| KEYSTONE XL PIPELINE PROJECT - STEELE CITY SEGMENT PIPELINE ROUTE VARIATION FORM | | | |

Assigned Tracking Number: 0192-SD-P2-297.5-298.8-I

| KEYSTONE US - PHASE IV PIPELINE PROJECT PROPOSED ROUTE VARIATION 0192 HARDING COUNTY, SOUTH DAKOTA | | | | | |

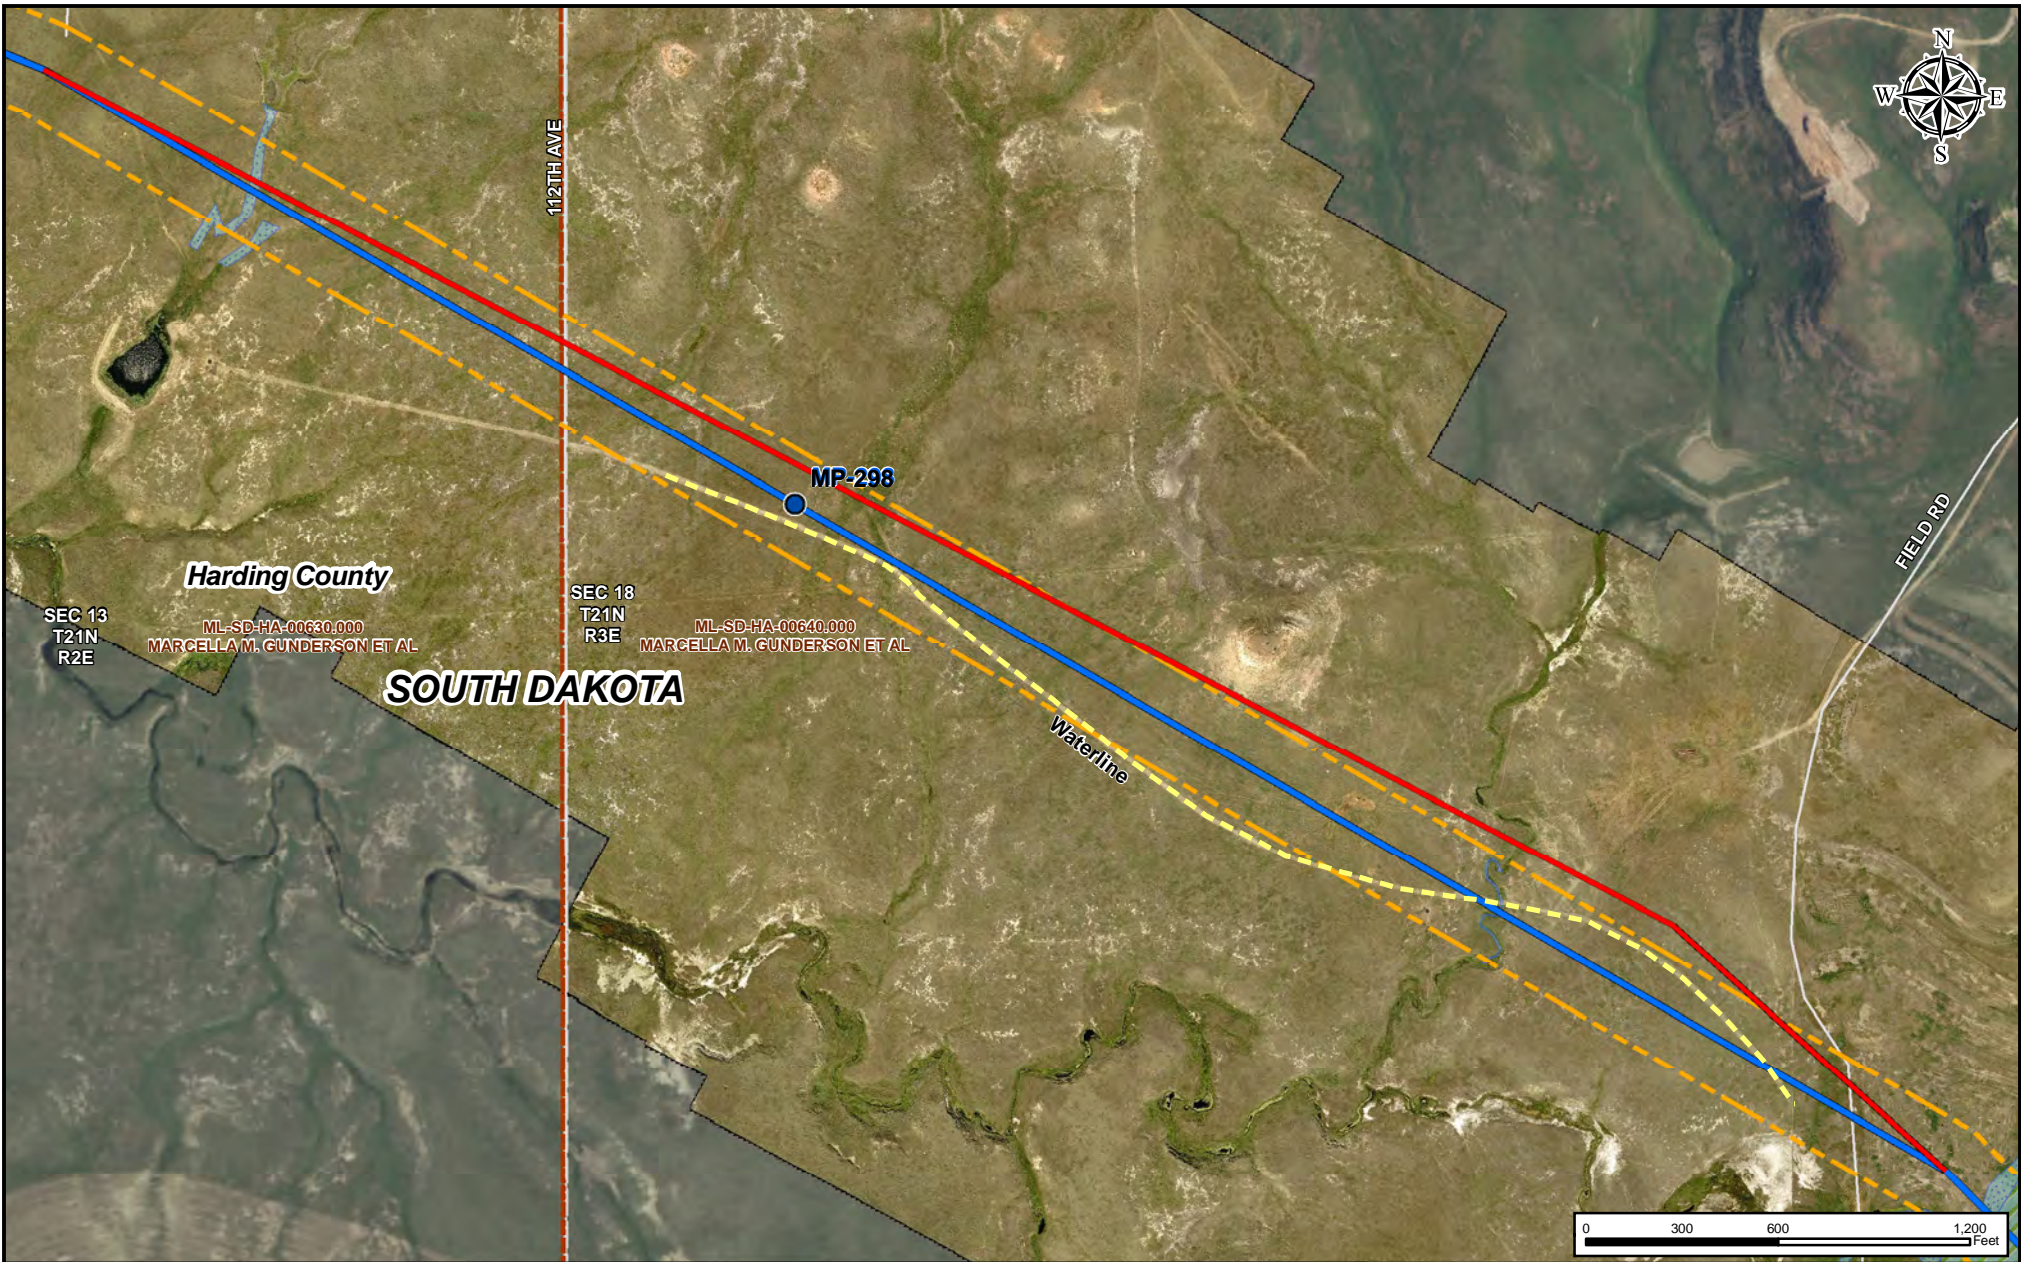
| KEYSTONE XL PIPELINE PROJECT - STEELE CITY SEGMENT PIPELINE ROUTE VARIATION FORM | | | |
|---|--|--|--|
| <p>The current centerline gets close to a waterline (1/2") near MP 298 and also crosses the waterline two times near MP 298.5. This reroute is proposed to accommodate landowner's request (Marcella M. Gunderson et al) to avoid these multiple waterline crossings which will also avoid delays and save cost of construction.</p> | | | |
| <p>The proposed reroute starts at the PI near MP 297.5 and deviates slightly (~2") from the centerline towards the east. It continues in this direction for ~5,750 ft until it is at a sufficient distance (~110ft.) to avoid any construction impacts to the landowner's waterline. Along its path, it crosses a minor stream feature at a preferred spot. It then turns towards the southeast and continues for ~1,140 ft to rejoin the current centerline at the PI near MP 298.8.</p> | | | |
| <p>The proposed reroute is ~29 ft longer than the original route. If the landowner is not agreeable to cut and replace the waterline during construction, the cost of matting and crossing the waterline at two locations is estimated to be ~\$30,000, there is a day of delay estimated at this location.</p> | | | |

| KEYSTONE PIPELINE PROJECT - U.S. PHASE IV (STEELE CITY SEGMENT) ROUTE VARIATION AUTHORIZATION FORM | | | |
|--|--|--|--|
| Comments: <input type="text" value="Environmental surveys will need to be completed."/> | <input type="text" value="Jonathan Minton"/> Date: <input type="text" value="12/13/2010"/> | | If Rejected Why? <input type="text"/> |
| Comments: <input type="text" value="This reroute slightly improves but does not substantially alter risk to HCAs. Therefore the reroute is therefore acceptable from a operational risk perspective."/> | <input type="text" value="Heidi Tillquist"/> Date: <input type="text" value="12/13/2010"/> | | If Rejected Why? <input type="text"/> |
